BOH FASI(S) ACP

Response on Design Principles

03 May 2022

CPJ-5663-RPT-016 V2

Figure 8: DP 3

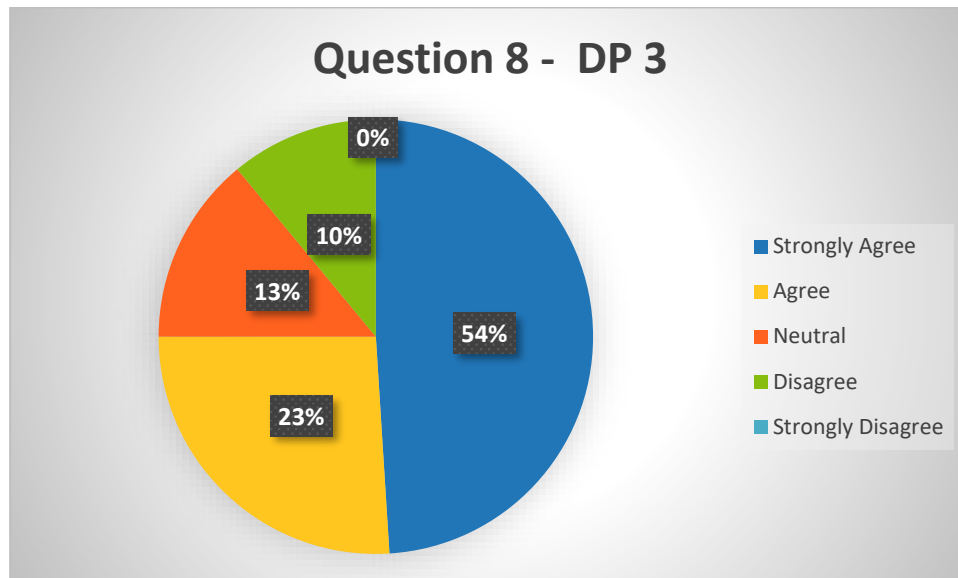
1. **Southampton Airport:** Consider wording, minimise and where possible reduce, more ambitious than to not increase.
2. **Broadstone Forum:** It goes without saying that noise is far less intrusive in a very densely built up area with high levels of traffic and I feel more thought should be given to those people who are subjected to intrusive noise from aircraft, especially at night. It seems that animals in the New Forest are given higher priority than is justified.

4. **ACC Member:** The airport noise action plan should be included in the design.
5. **ACC Member:** Not Sure, the airport noise action plan should be included in the design.

The feedback received from Question 5 of the survey encapsulates the stakeholders desire to provide built in periods of respite. In response to stakeholder feedback this DP has been amended to reflect a holistic approach to minimising noise and reworded as follows:

Final wording of Noise DP - The design should limit, and where practicable reduce, the number of people overflown, the impact of noise to stakeholders on the ground, in line with the Bournemouth Airport Noise Action Plan, and where possible periods of built-in respite should be considered.

Figure 9: DP 4

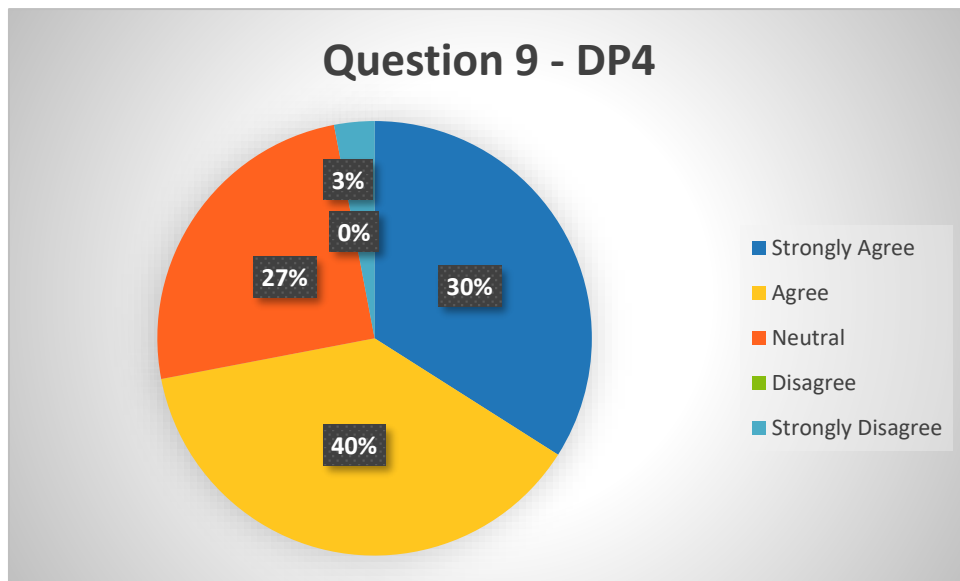
1. **National Trust:** As well as tranquillity, affects on places important for the tourism and visitor economy (although the places we've mentioned in our responses are all in AONBs).

Whilst CAP1616 states that 'where practicable, it is desirable that airspace routes below 7,000 feet should seek to avoid flying over Areas of Outstanding Natural Beauty (AONB) and National Parks', following the response to stakeholder feedback and Question 4 of this survey this DP will be amended to include sites of cultural and environmental interest as well as tourism.

Figure 10: DP 5

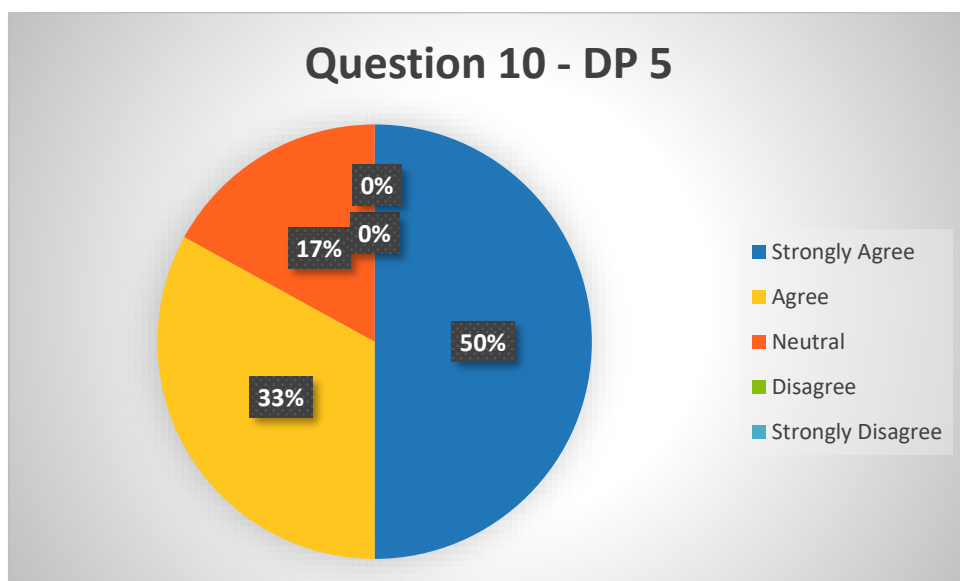
1. **Southampton Airport:** Consider wording, minimise and where possible reduce, more ambitious than to not increase.
2. **Poole People Party:** The design should seek to reduce air travel and transport through Bournemouth to meet net-zero commitments.

As a result of stakeholder feedback, the DP is revised to reflect an ambition to stabilise and, if possible, improve the situation with respect to air quality and emissions. Bournemouth Airport is committed to minimise environmental impact through the most efficient airspace and

Figure 15: DP 10

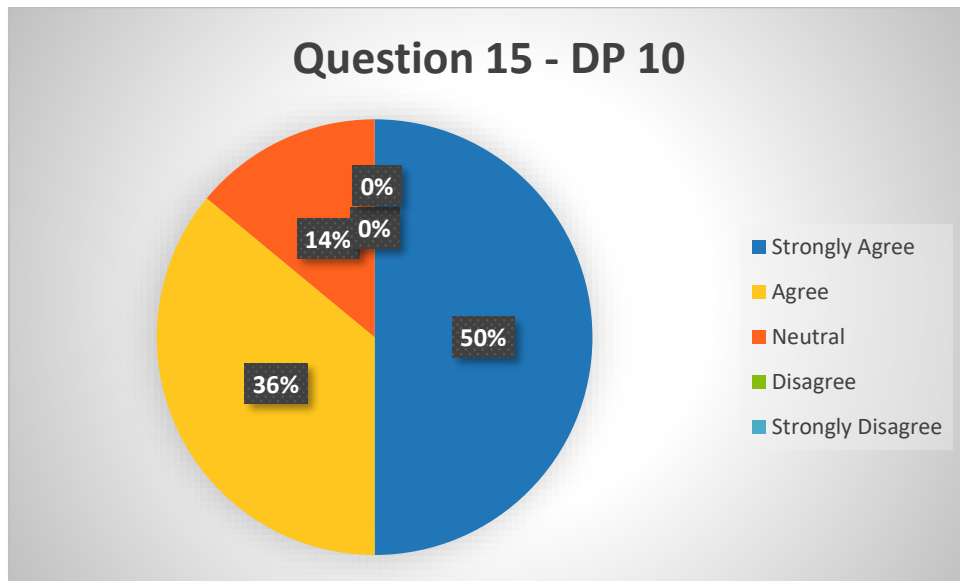
Southampton Airport: Perhaps should be fully compliant, any non-compliance to be acceptable to the CAA.

Figure 16: DP 11

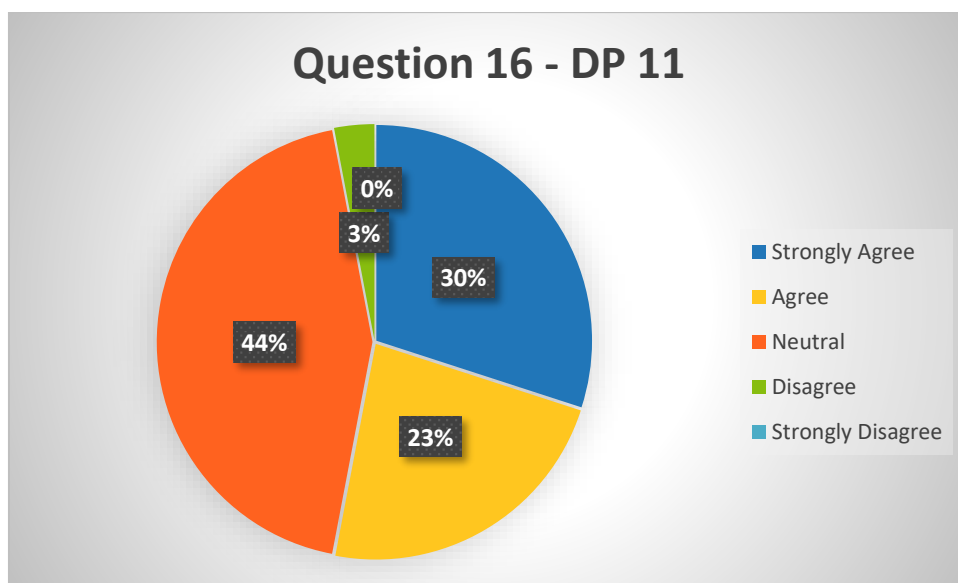
Southampton Airport: We believe this DP is covered by IFP Validation Policy or if wish to retain use all aircraft families (rather than every type).

Figure 17: DP 12

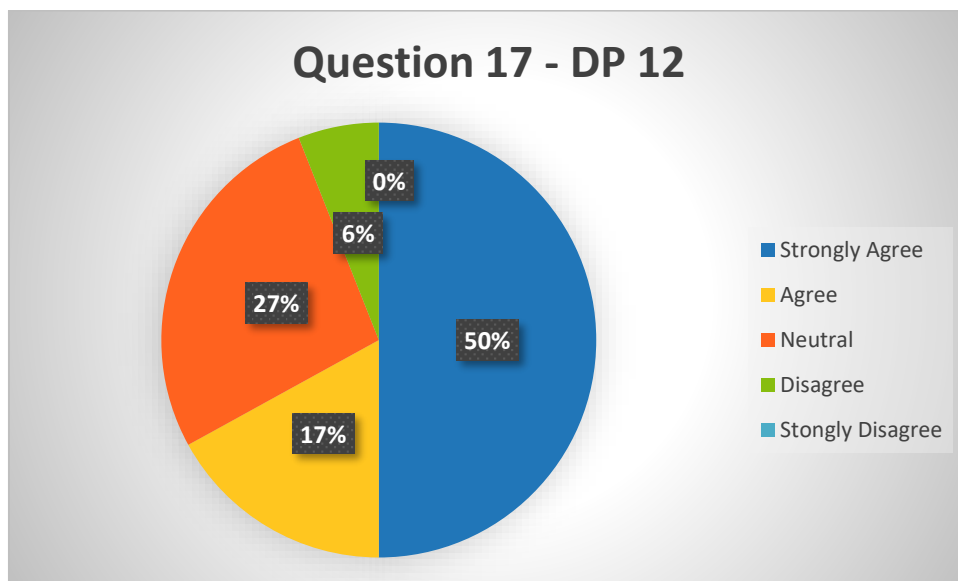
1. **Southampton Airport:** Could be combined with DP6?

Figure 19: DP 14

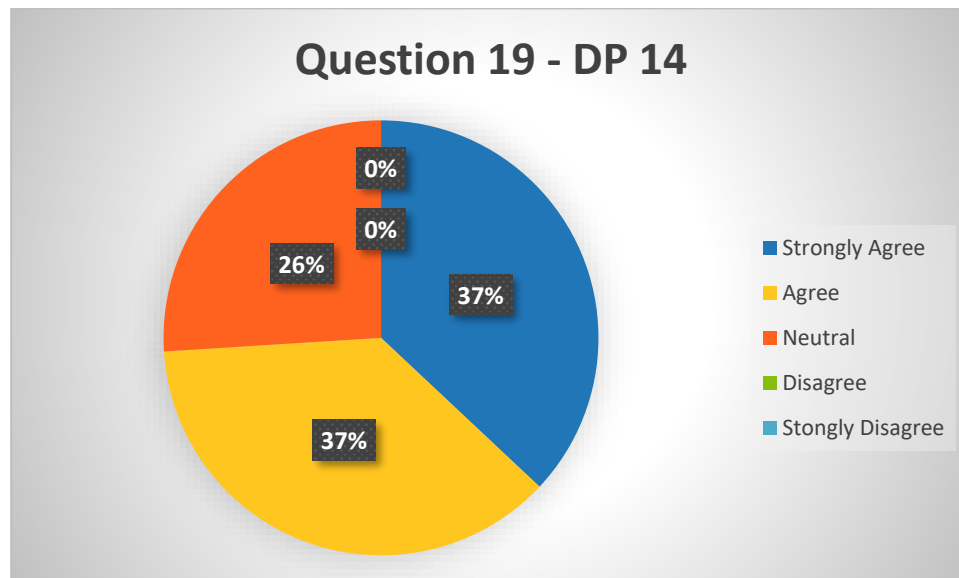
1. **Southampton Airport:** Gateways are no longer the method of design in FASI(S). Perhaps the SIDs should be deconflicted from arrivals transitions.

Figure 21: DP 16

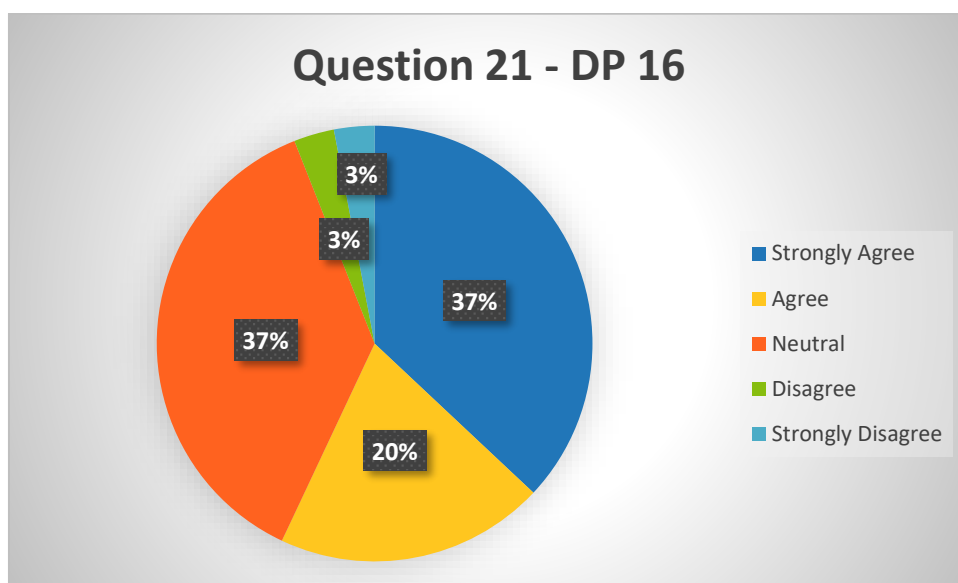
1. **Southampton Airport:** Potential new DP: Routes to/from Bournemouth and Southampton Airports must be procedurally deconflicted in coordination with NATS.
